Subject: ISSUANCE OF AMENDMENT NO. 49 TO FACILITY OPERATING LICENSE NPF-21 -
WPPS NUCLEAR PROJECT NO. 2 (TAC NO 59798)

ENCLOSURE TO LICENSE AMENDMENT NO. 49

SAFETY EVALUATION BY THE OFFICE OF NUCLEAR REACTOR REGULATION
SUPPORTING AMENDMENT NO. 49 TO FACILITY OPERATING LICENSE NO. NPF-21
WASHINGTON PUBLIC POWER SUPPLY SYSTEM
WPPS NUCLEAR PROJECT NO. 2
DOCKET NO. 50-397

FIGURE 6.2.2-1a
UNIT ORGANIZATION

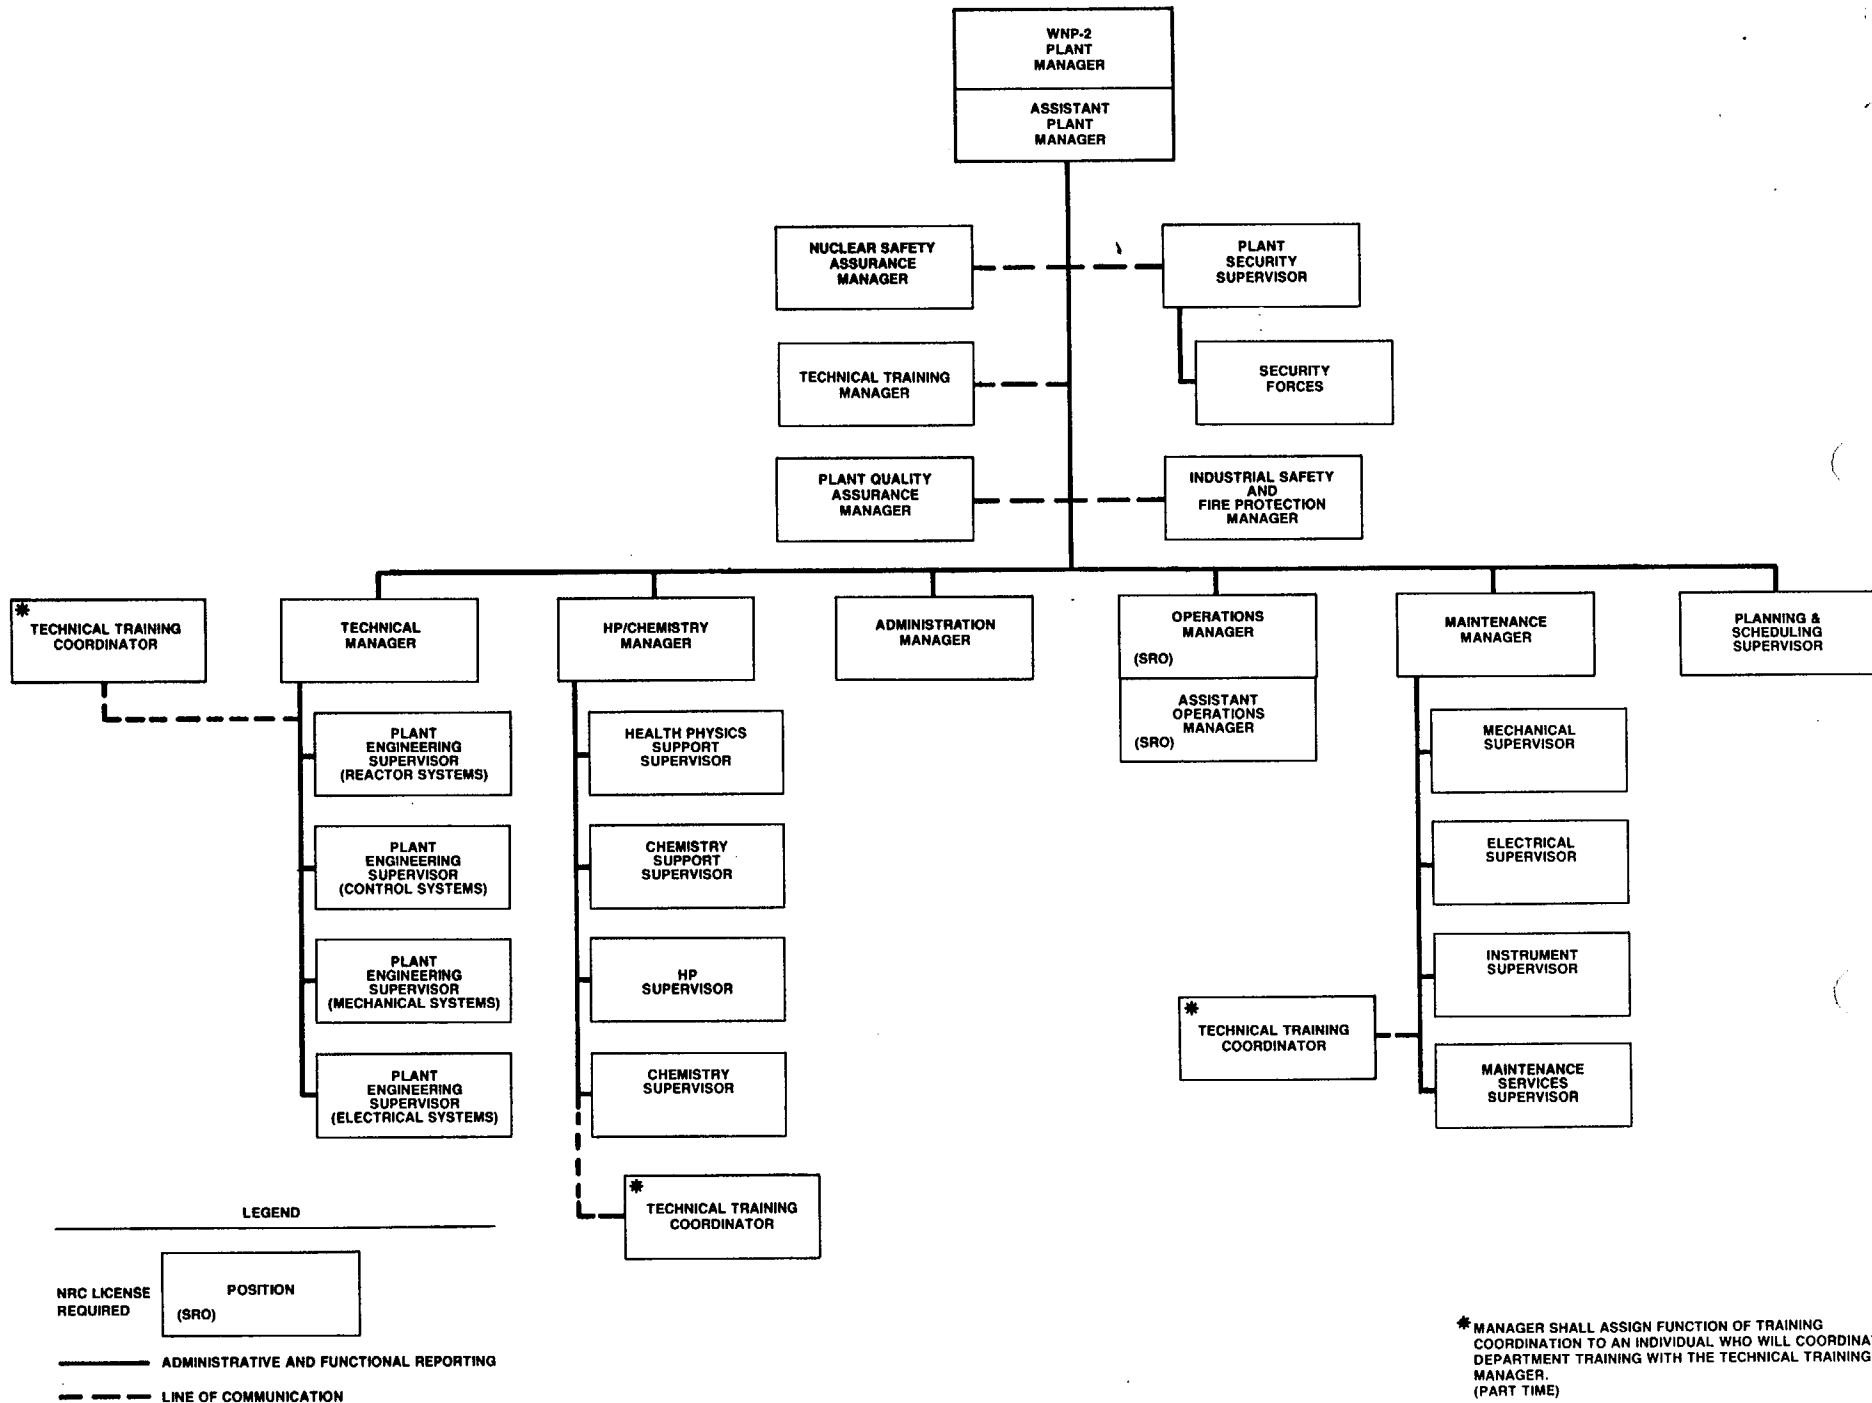
This amendment revises WNP-2 Technical Specifications Section 6.4.1 and the organization charts in Figures 6.2.2-1a and 6.2.2-1b to reflect organizational and other administrative changes at WNP 2.

- The title "Industrial Safety Supervisor" has been changed to "Industrial Safety and Fire Protection Manager."
- The title "Reactor Engineering Supervisor" has been changed to "Plant Engineering Supervisor (Reactor Systems)."
- The title "Plant Engineering Supervisor" has been changed to "Plant Engineering Supervisor (Control Systems)."
- The title "Plant Engineering Supervisor" has been changed to "Plant Engineering Supervisor (Mechanical Systems)."
- The title "Health Physics Chemistry Support Supervisor" has been changed to "Health Physics Support Supervisor." The Chemistry Support function has been transferred to the new position of Chemistry Support Supervisor.

- Chemistry Support Supervisor - This function was formerly performed by the Health Physics Chemistry Support Supervisor.

- Plant Engineering Supervisor (Electrical Systems) - This function was formerly performed by a Plant Engineering Supervisor who had responsibility for both control systems and electrical systems.
- Assistant Operations Manager - This position was created to provide assistance to the Operations Manager.

- The position of Procurement Manager that reported to the Maintenance Manager now reports to the Manager Operations Controls and Material.
- The function of the position of Planning/Scheduler that reported to the Maintenance Manager has now been transferred to the Planning and Scheduling Supervisor who reports to the Plant Manager.
- The responsibility for the retraining and replacement training has been assigned to the Technical Training Manager. Each plant staff department manager shall assign the function of training coordinator to the individual who will coordinate the department training with the Technical Training Manager.

* MANAGER SHALL ASSIGN FUNCTION OF TRAINING COORDINATION TO AN INDIVIDUAL WHO WILL COORDINATE DEPARTMENT TRAINING WITH THE TECHNICAL TRAINING MANAGER. (PART TIME)
